**RECONSTRUCTION OF ENCINA AVENUE
FROM MIDDLEFIELD ROAD TO END**

**COUNTY PROJECT NO. RW703
PROJECT FILE NO. E5044000**

ADDENDUM NO. 1

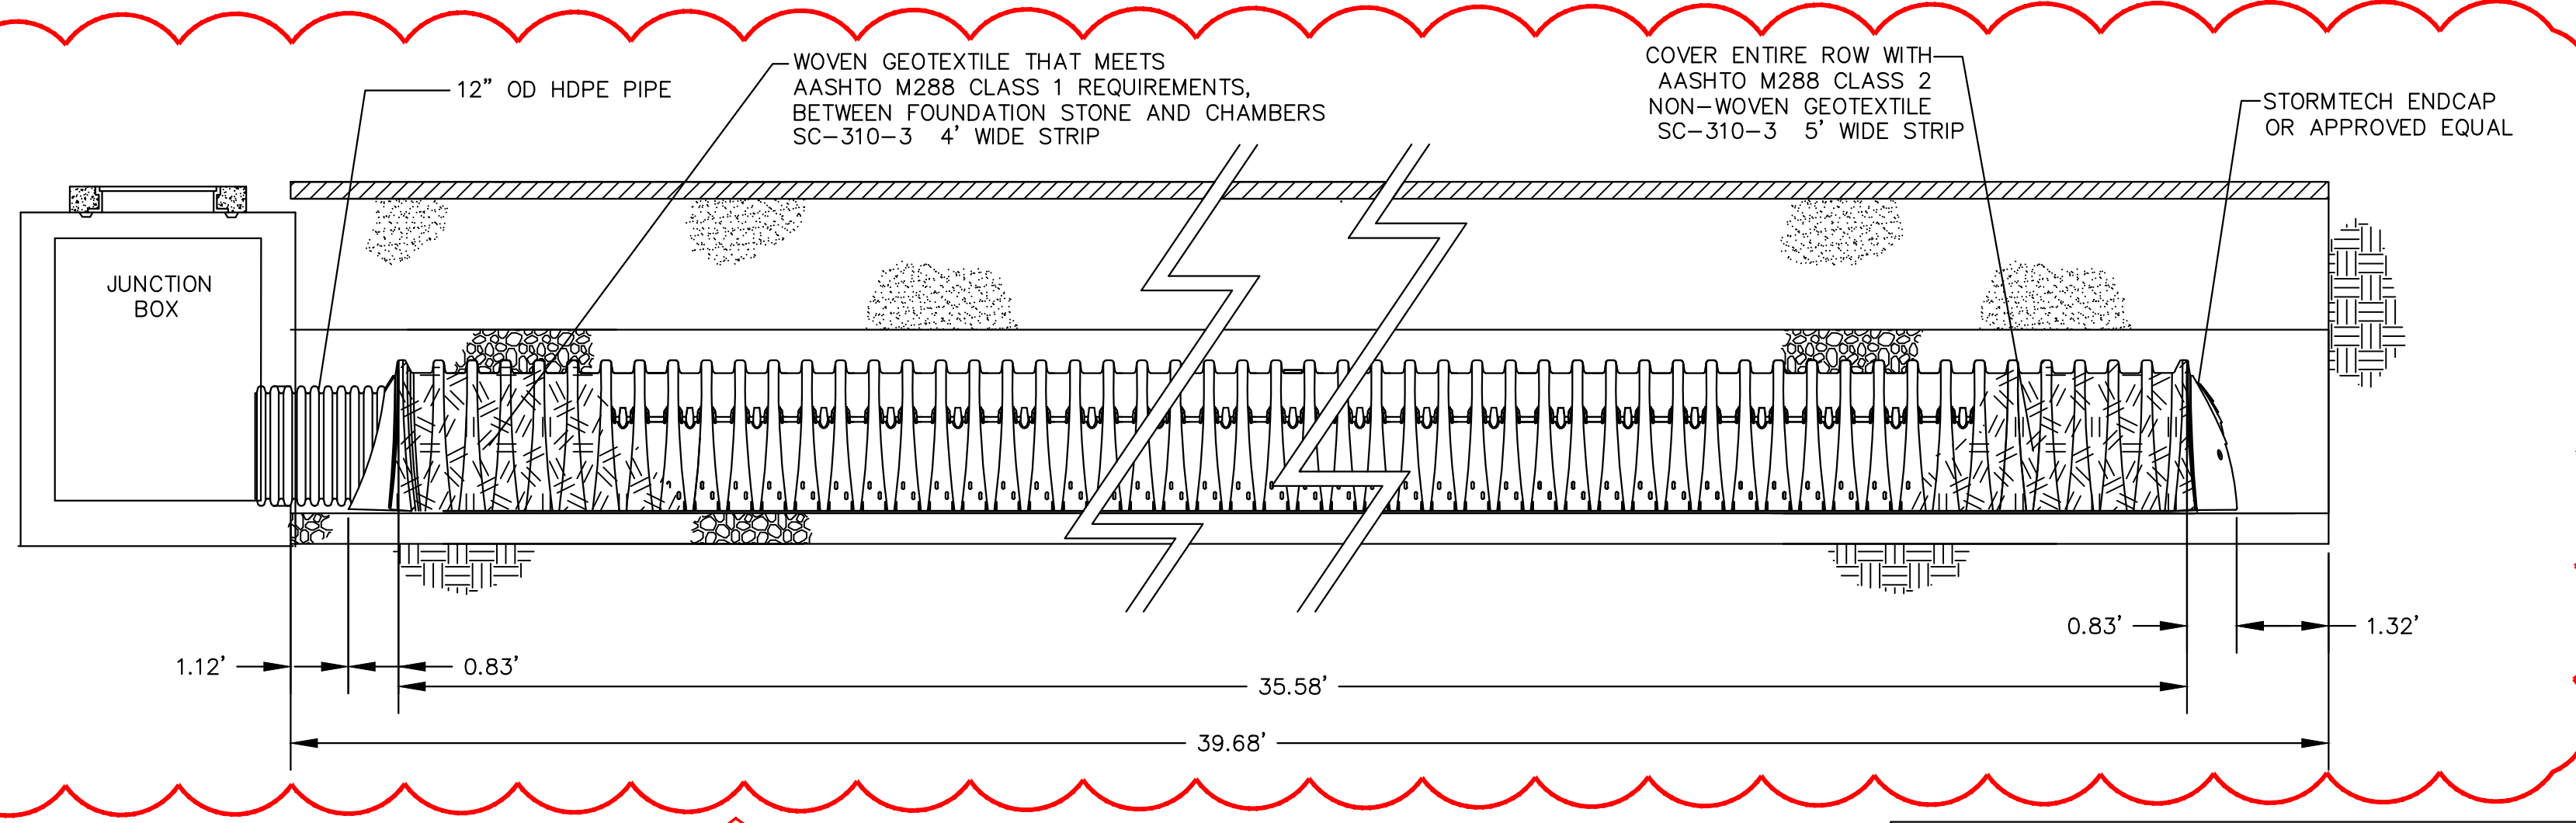
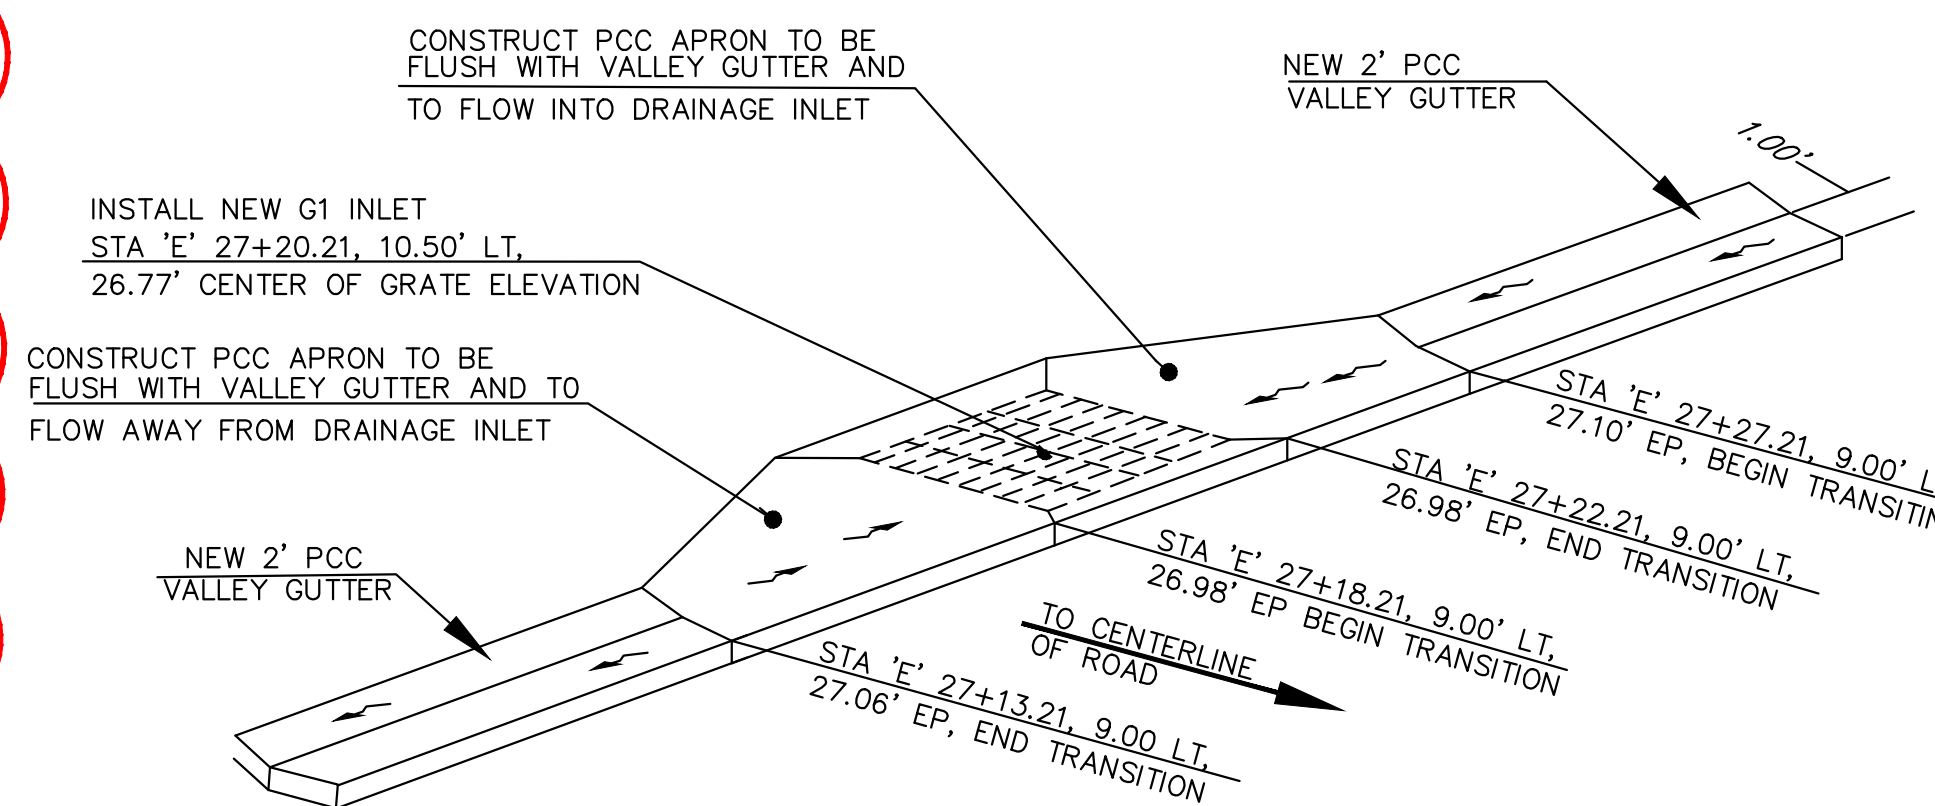
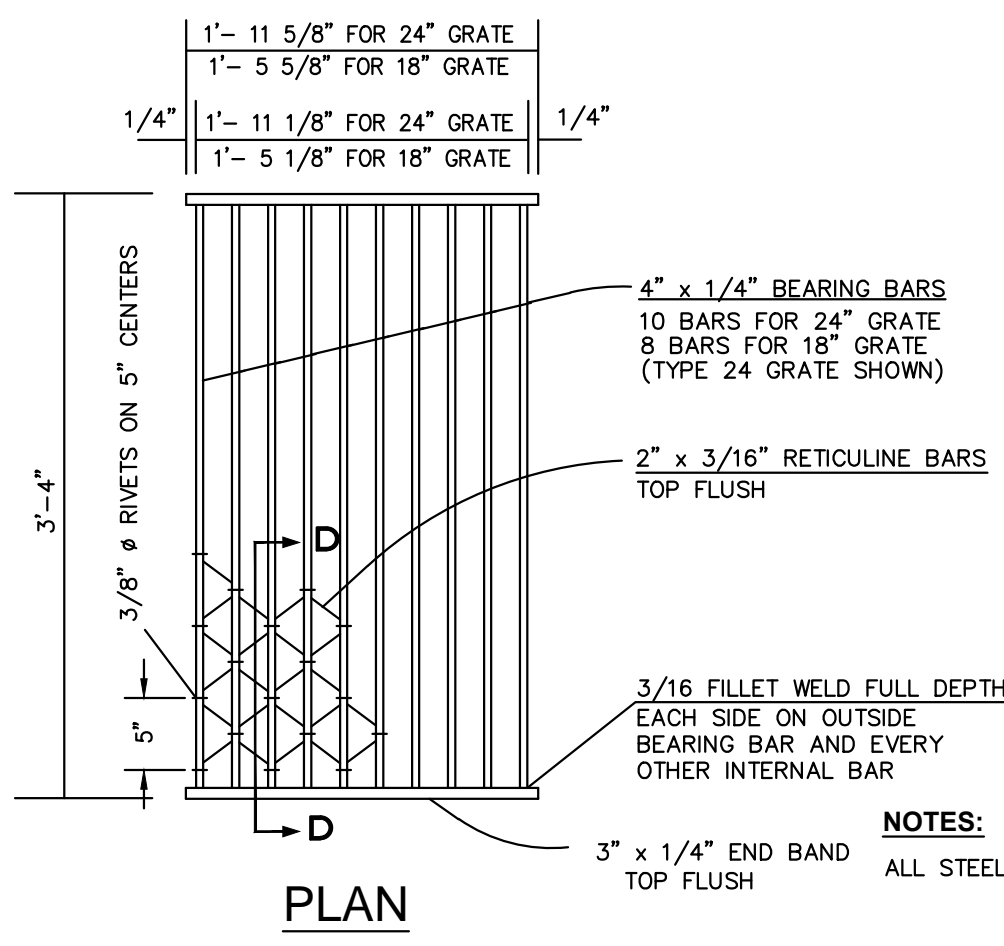
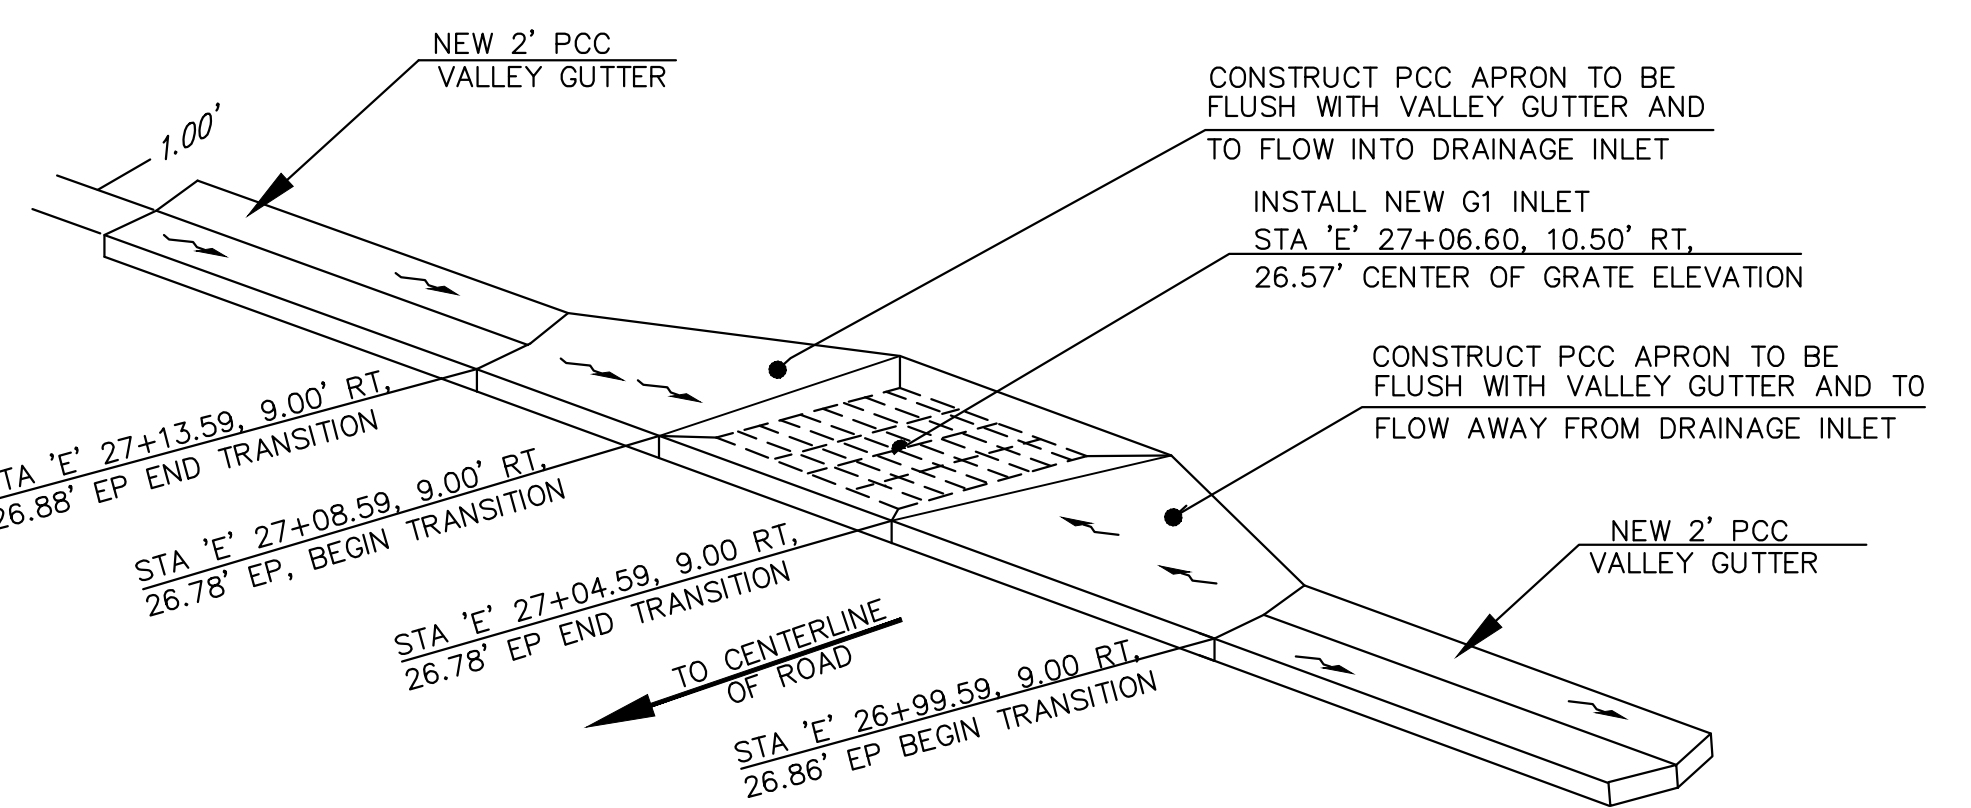
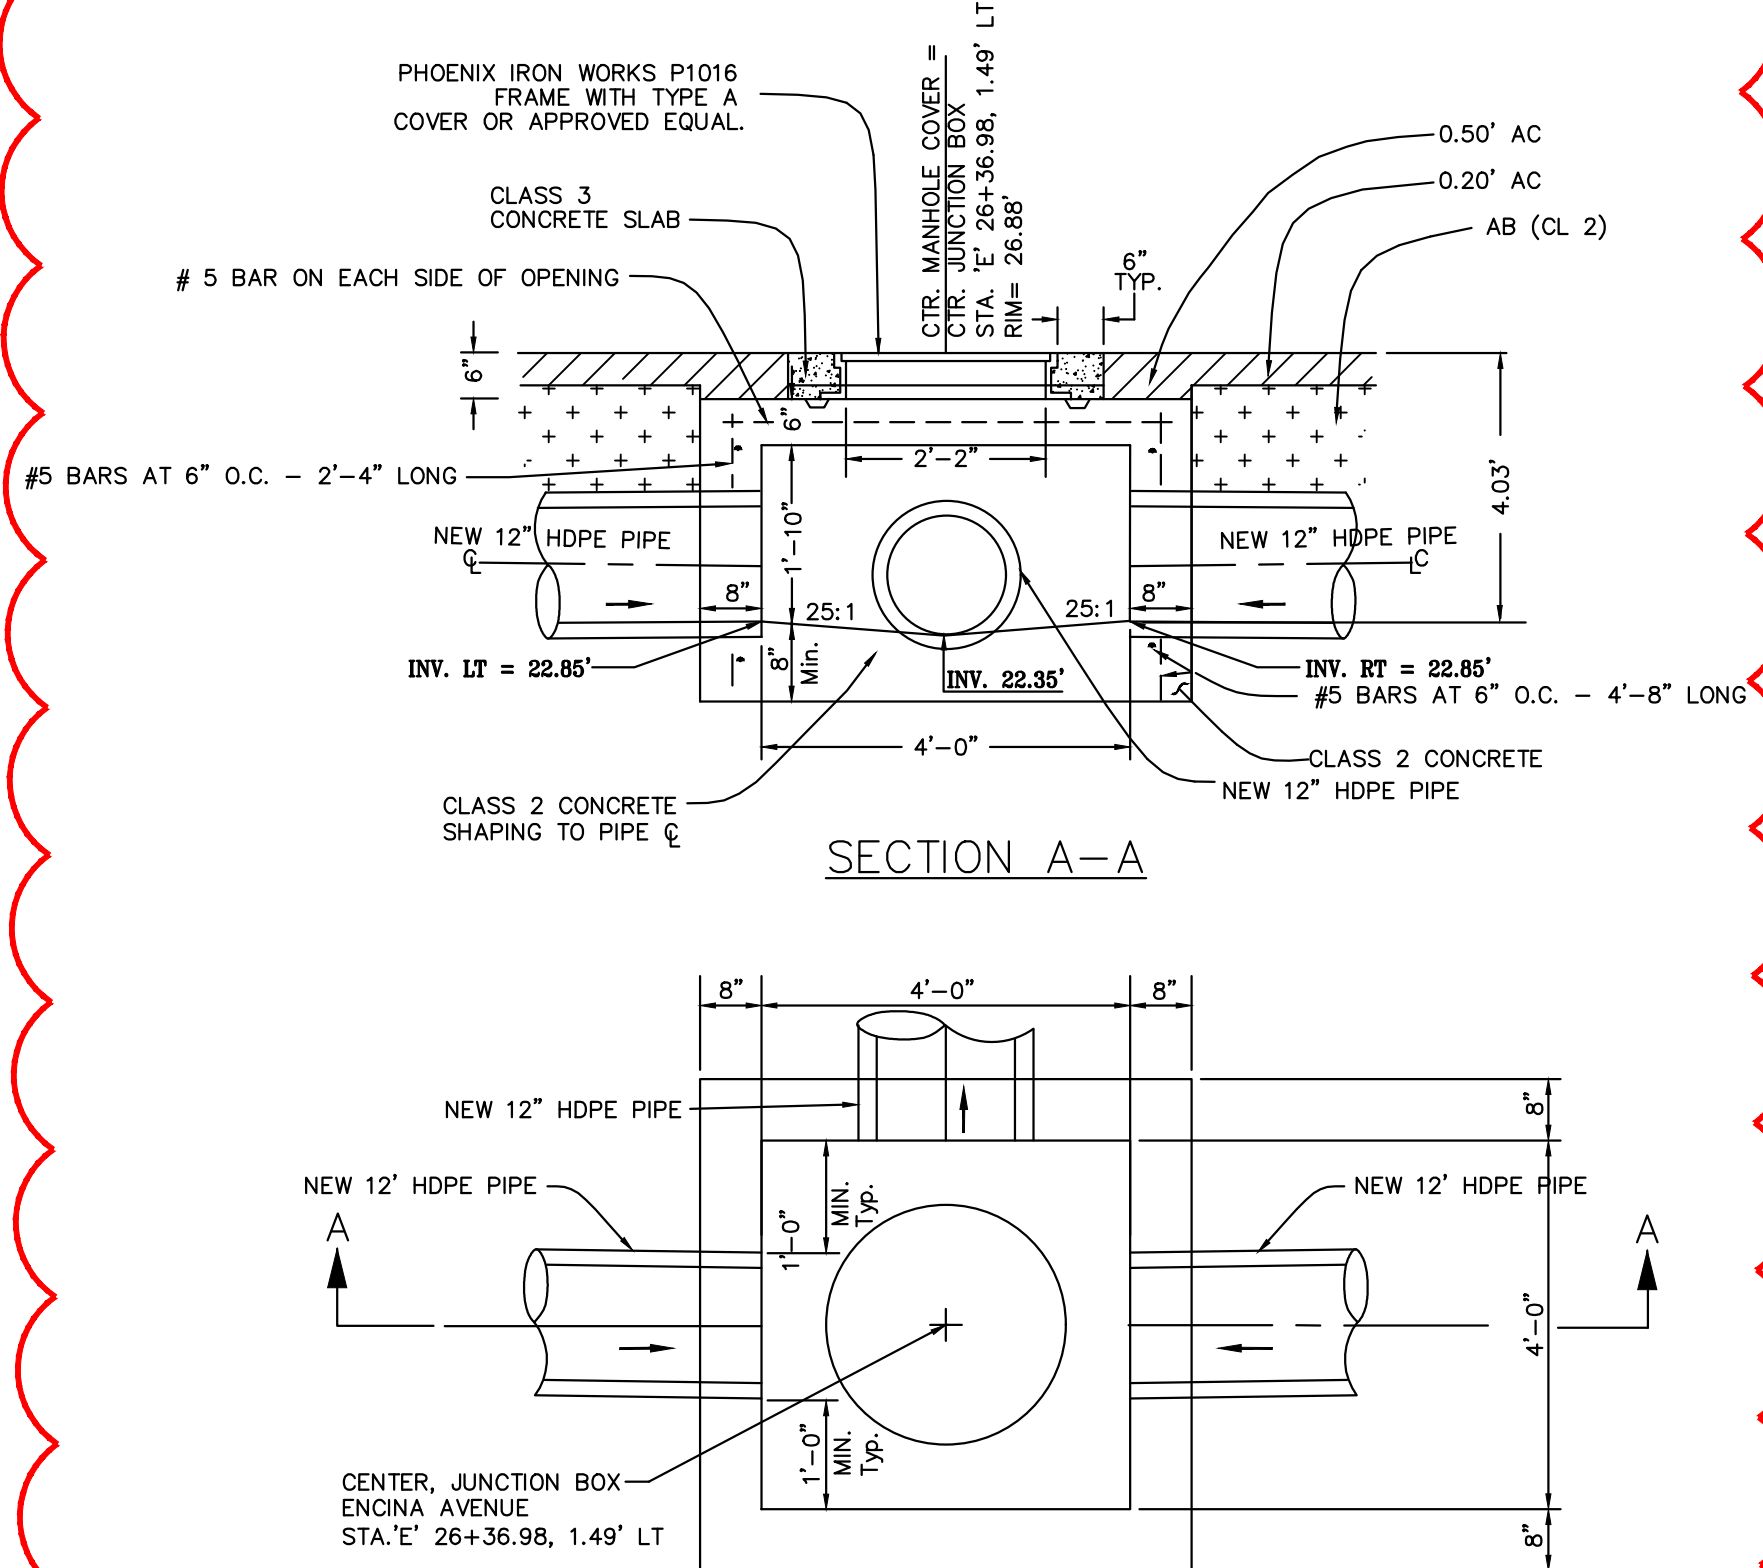
1) LENGTH, ELEVATIONS AND LOCATION OF INFILTRATION GALLERY, CATCH BASINS, STORM DRAIN MANHOLES AND STORM CHAMBERS

1) LENGTH, ELEVATIONS AND LOCATION OF INFILTRATION GALLERY, CATCH BASINS, STORM DRAIN MANHOLES AND STORM CHAMBERS
